Client **Capital Compactors Ltd**
Barnsley, S79 9LH

Project **Temporary Structure**
334 Profile, concrete surface

Title **Plan & Elevations JH**
20Mx26.5Mx6.2M
Non-Insulated

Elevation A

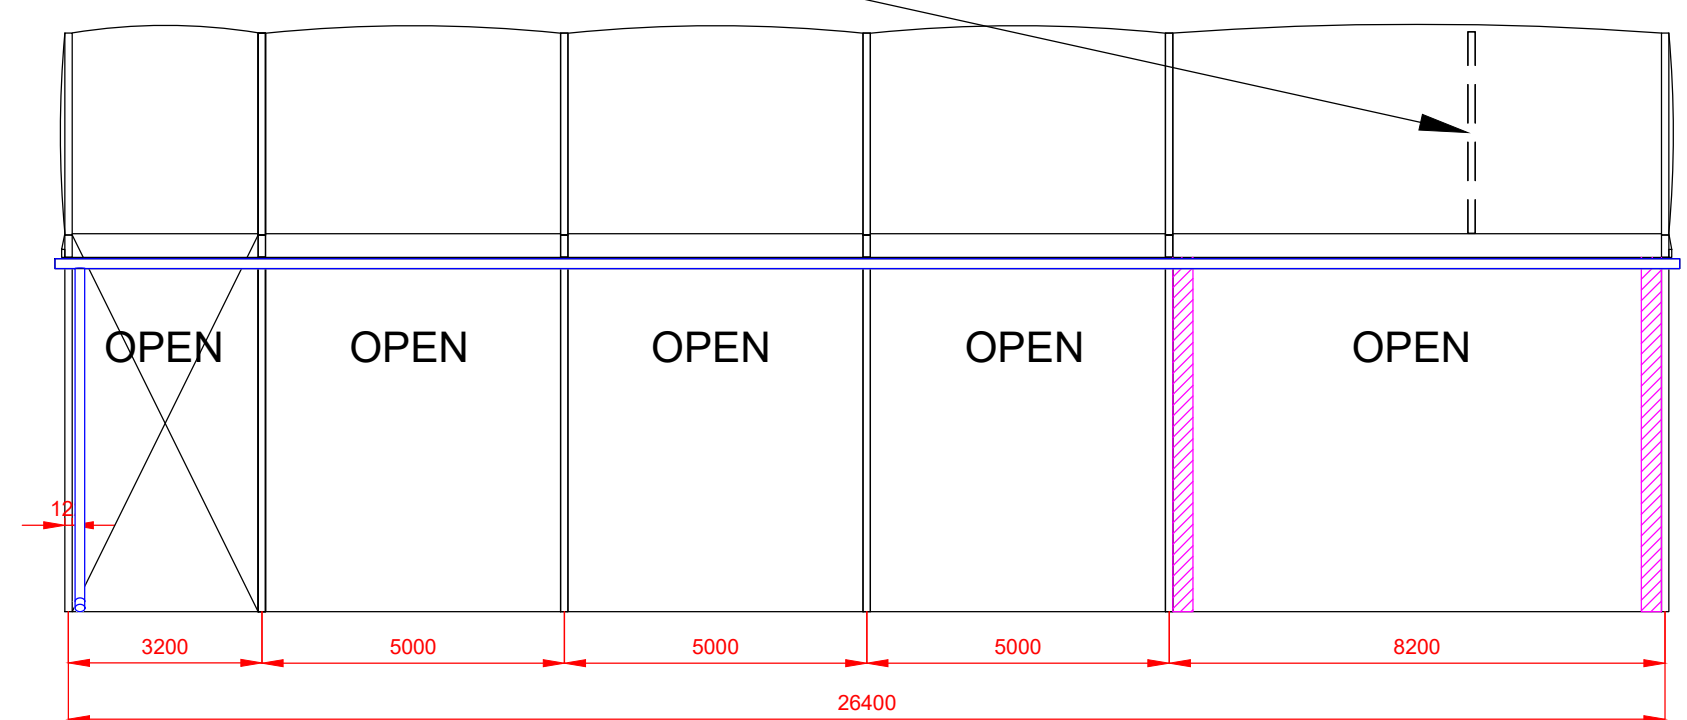
ALL UPRIGHTS
INCLUDING PORTALS
SHOWN ON ELEVATION A
NEED TO BE
REDUCED BY 800mm

Elevation C

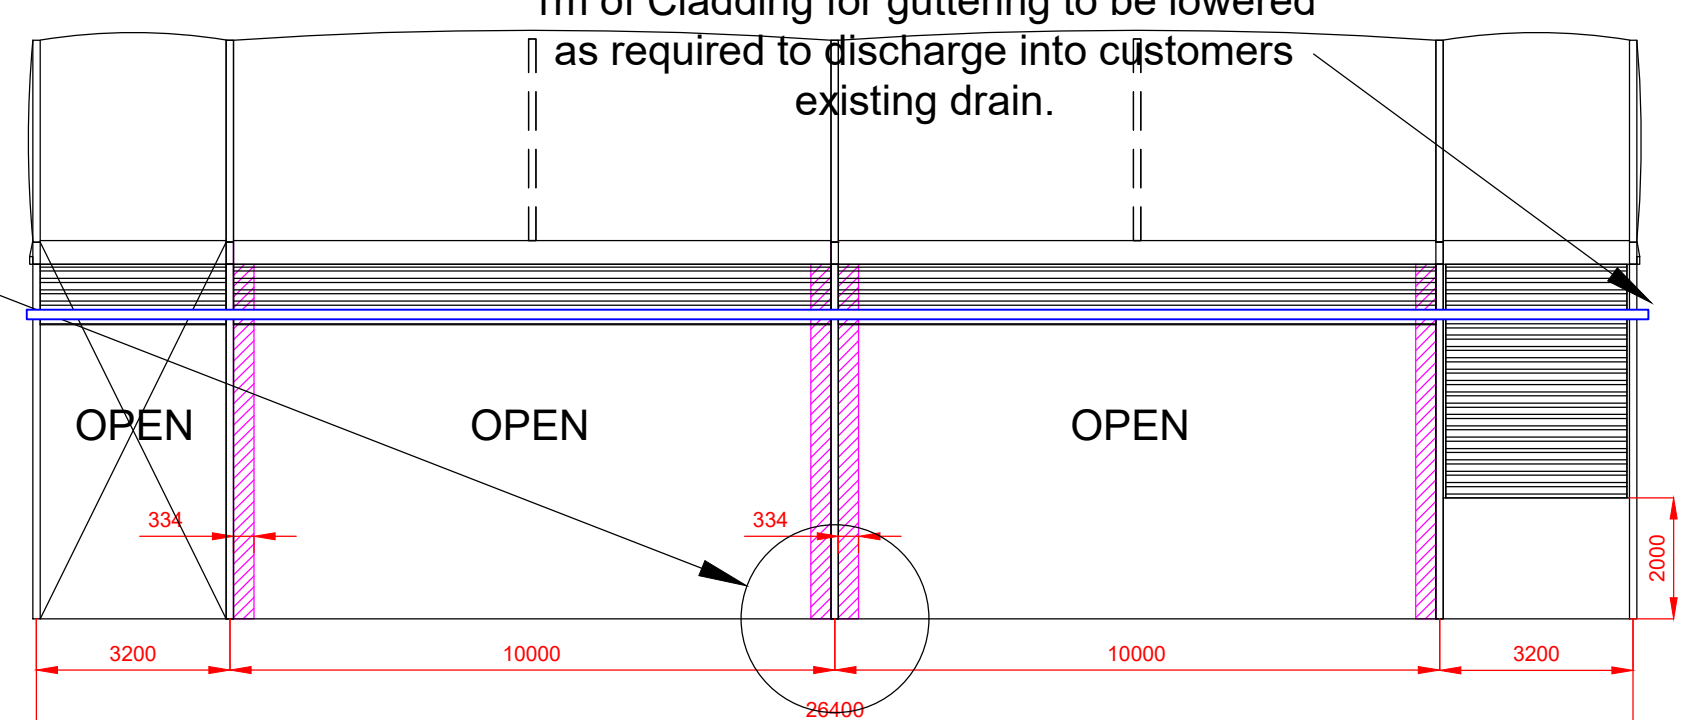
UPRIGHT AND PORTALS
HIGHLIGHTED ON
ELEVATION C, THAT
SIT ON TOP OF THE RAMP
TO BE REDUCED BY 200mm
